PRAIRIE POINT (FKA KINGS POINT NORTH)
WEST INFRASTRUCTURE SITE PLAN AMENDMENT NO. 1

WEST INFRASTRUCTURE SITE PLAN COVER SHEET

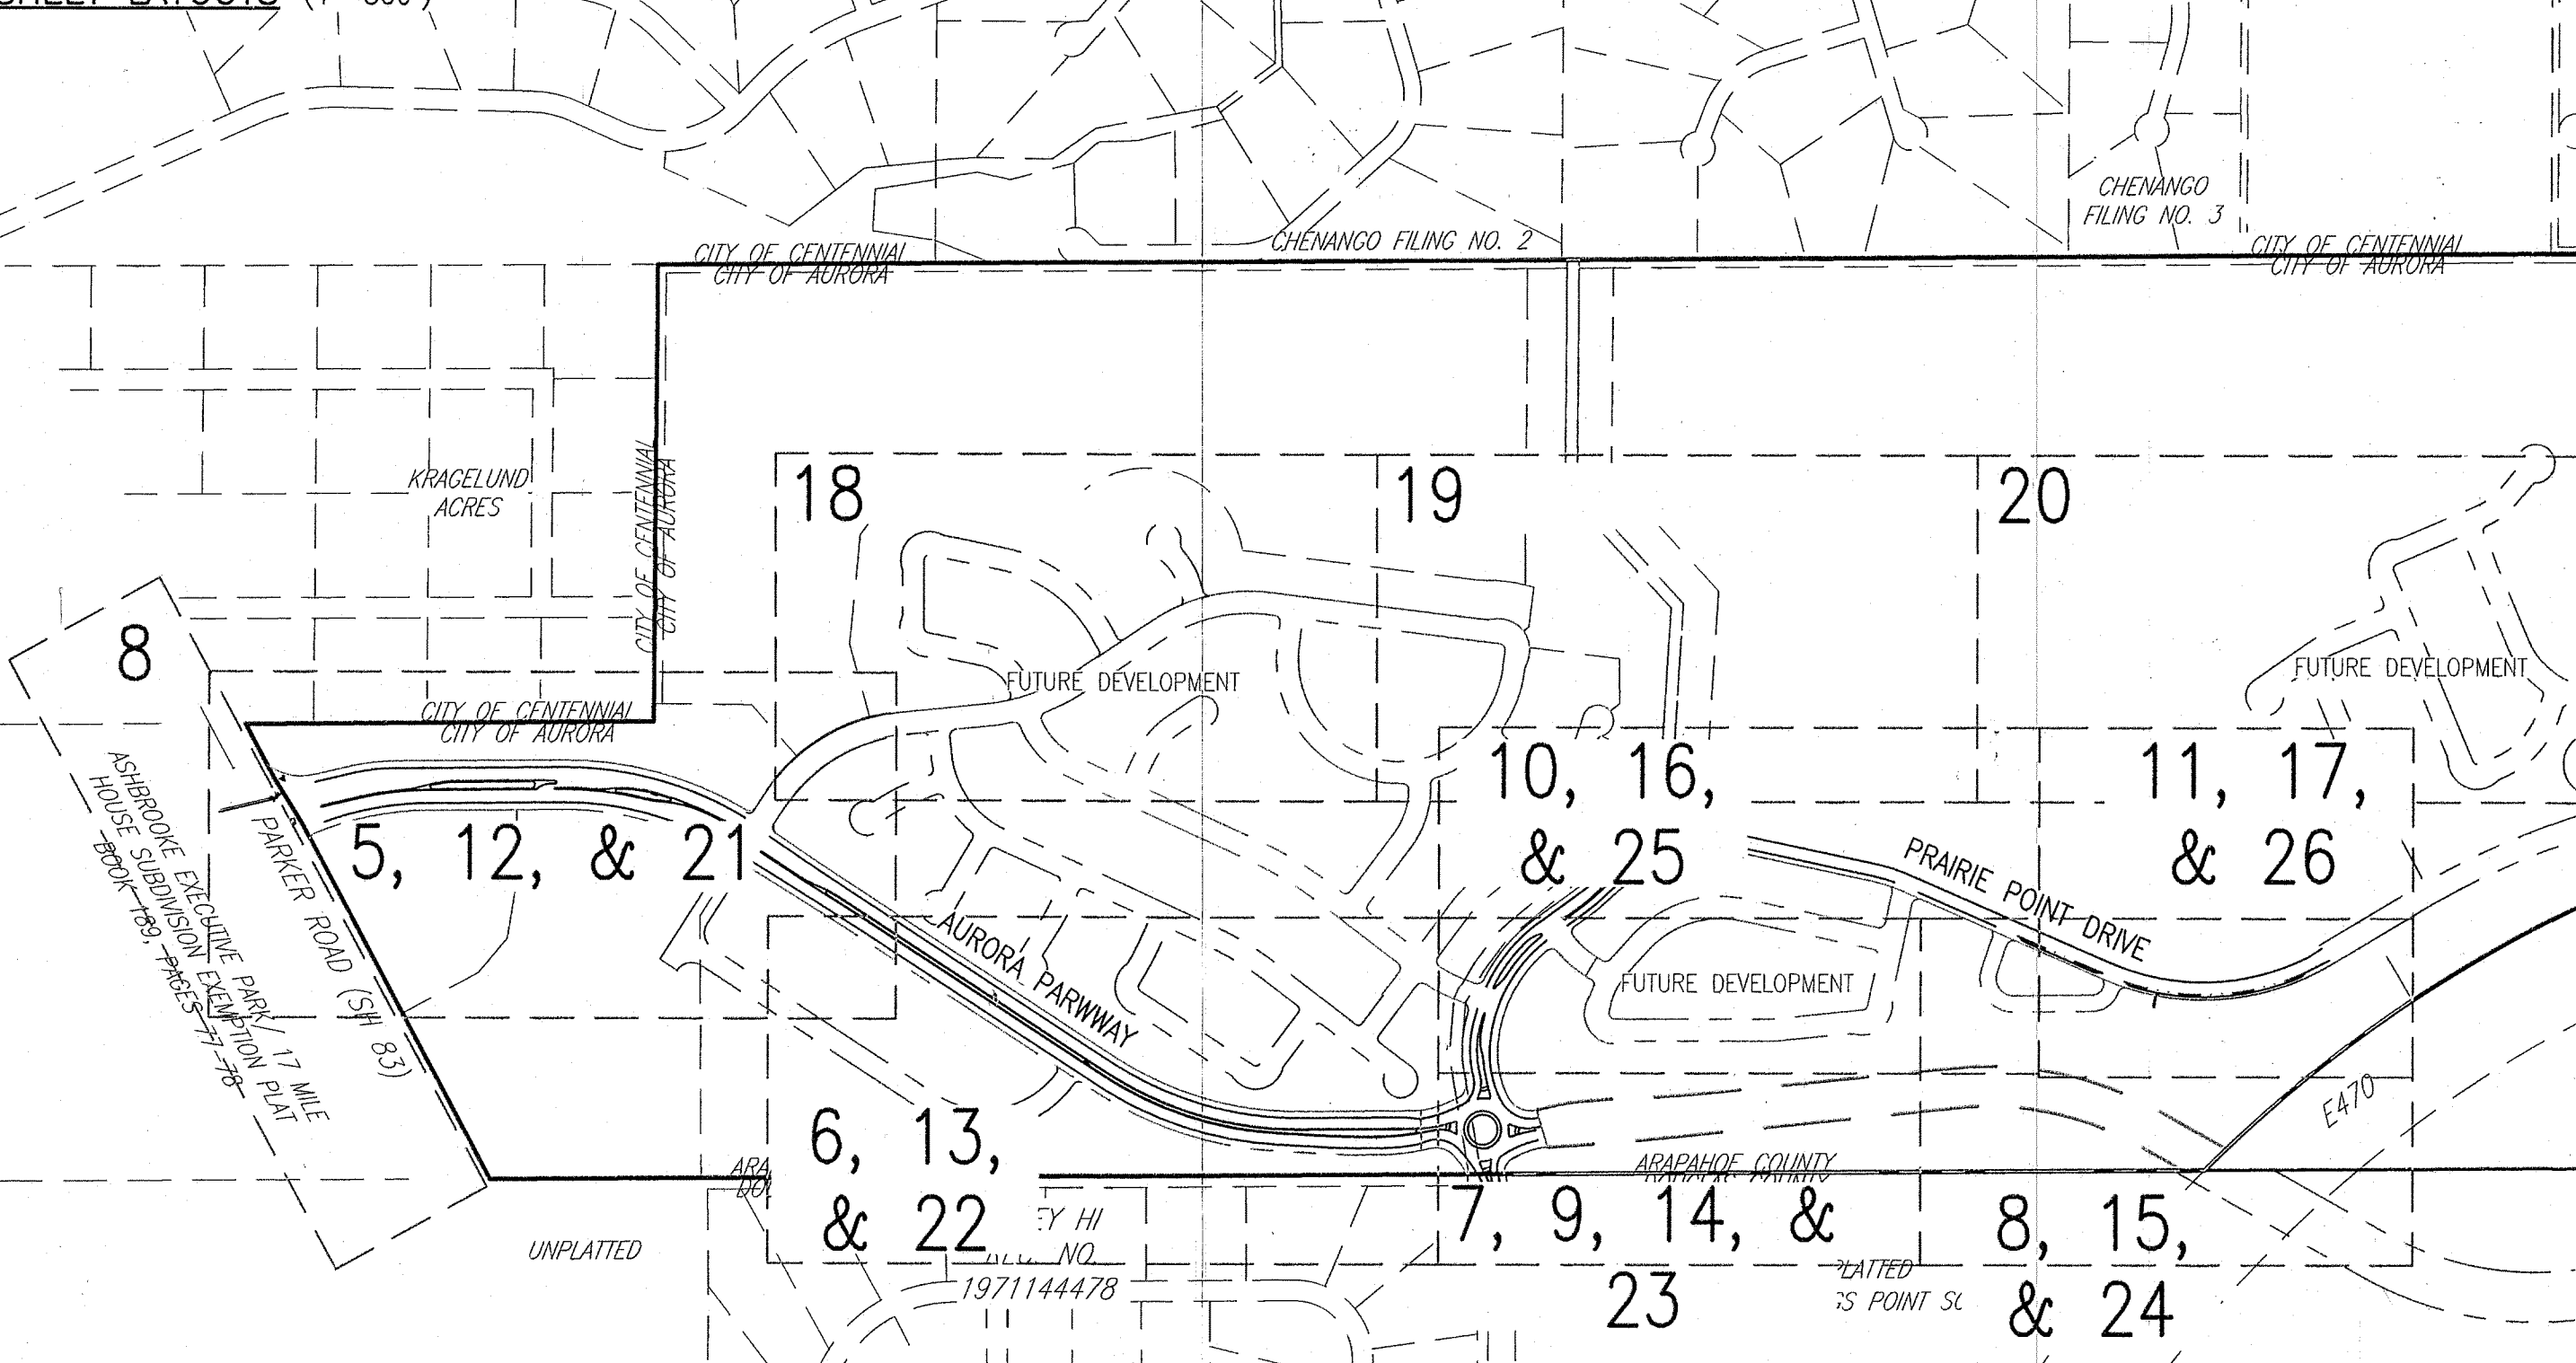
- AMENDMENT NO. 1 02/28/2025
- REVISE AURORA PARKWAY AS IT APPROACHES PARKER ROAD AS FOLLOWS:
 - WIDEN MEDIAN FROM 4' FLOWLINE WIDTH TO 9';
 - MOVE NORTH CURB 5' TO THE NORTH;
 - MOVE WESTBOUND LANES 5' TO THE NORTH.
 - REVISE AURORA PARKWAY CROSS SECTIONS TO ELIMINATE RAISED LANDSCAPE MEDIANS AND REVISE MEDIAN BORDER PAVING TO COBBLE PER THE LANDSCAPE PLAN.
 - MOVE HIGH PLAINS TRAIL CONNECTION TO THE EAST.
